3441XA-01A

S E R V I C E N O T E

34410A/34411A 6 ½ digit DMM

Procedure to latch display PCA if not properly installed.

Front Panel PCA – Properly Latched

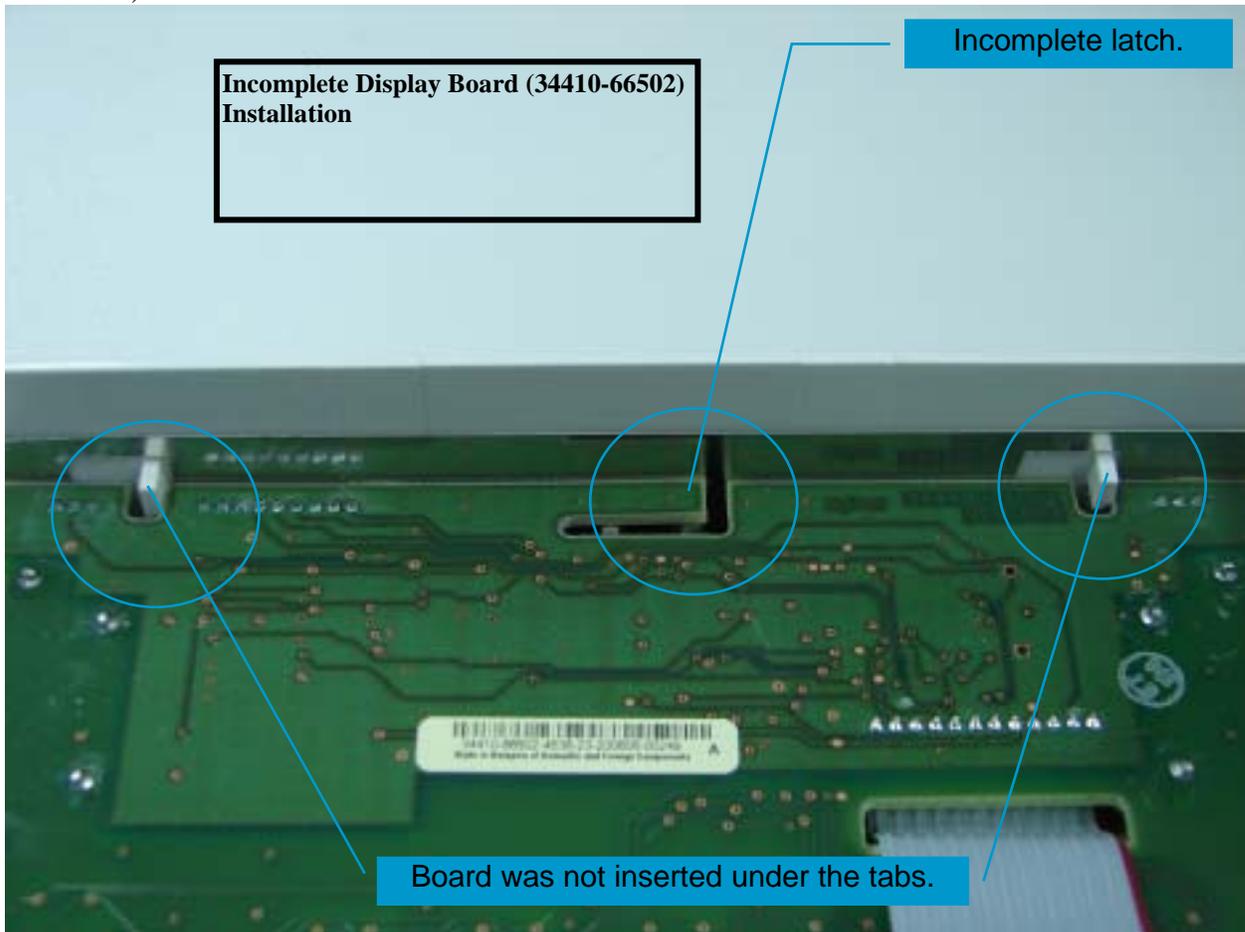
Some 34410A and 34411A 6 ½ digit DMMs have a PCA (33410-66502) that is unlatched and the board is not inserted properly under the tabs which causes the front panel to be inoperable. When pushing the buttons, there is no response from the DMM. (Incomplete latch and board not inserted in tabs below):

Follow the directions in the 34410A/11A Service Guide to remove the front panel (<http://cp.literature.agilent.com/litweb/pdf/34410-90010.pdf> Chapter 4 - Disassembly and Repair). Remove the front panel from the instrument and push the PCA into place until it latches. (Latched PCA picture below) Reverse the procedure to assemble the 34410A/11A. Please note that once you remove the cover and/or the front panel, the unit must be re-calibrated.
